1.2 DA-24-00388 - Additional 76 apartments to approved residential flat buildings - 60 Pelican Rd, Schofields

Sydney Central City Planning Panel

Panel reference: PPSSCC-552

Report prepared by	Bertha Gunawan
Report date	17 January 2025
Recommendation	Approval, subject to deferred commencement consent conditions listed in attachment 9

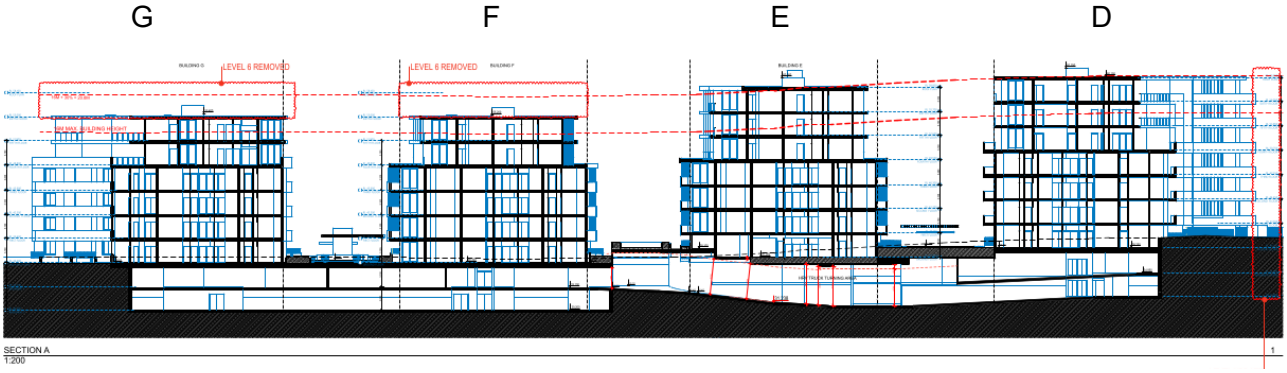
The sections and elevation drawings below further illustrate the height non-compliance.
